The preparation of the Study Plan, Environmental Impact Assessment (with N2000 impact assessment), obtaining environmental permit of the road section between Győr, east by-pass road - state border
 Study Plan
 PST: K014.02

Development of the Vámosszabadi – state border section extension to 2x2 lanes arrangement

Environmental Impact Assessment

Response to the comments of the Slovak Partner (4182-63/2019. ref. no.)

Graph 1: Map of the road network expected in 2020

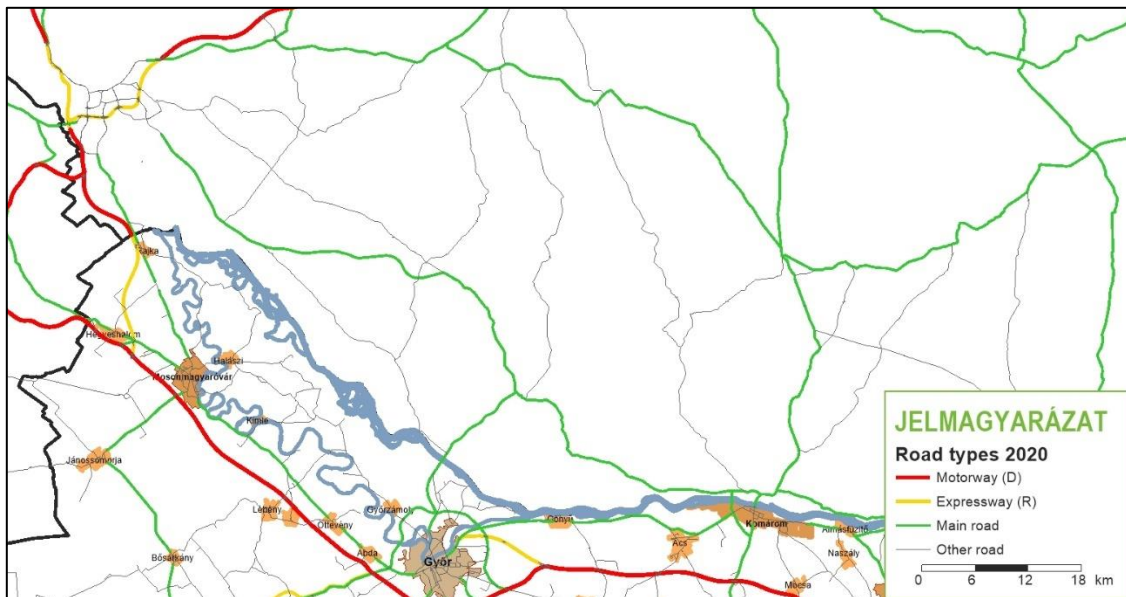
1st objection: Traffic model

The TRENECON Consulting and Planning Ltd. completed a detailed traffic assessment as a part of the study plan. The traffic model used for the documentation contained the main road network elements highlighted in the Slovak Partner’s request (Slovak roads: D2 motorway, I/13 and

Hungarian roads: M15, highway No.14, the old and new bridge in Komárom) (see: graph 1) and the model was built by considering them.
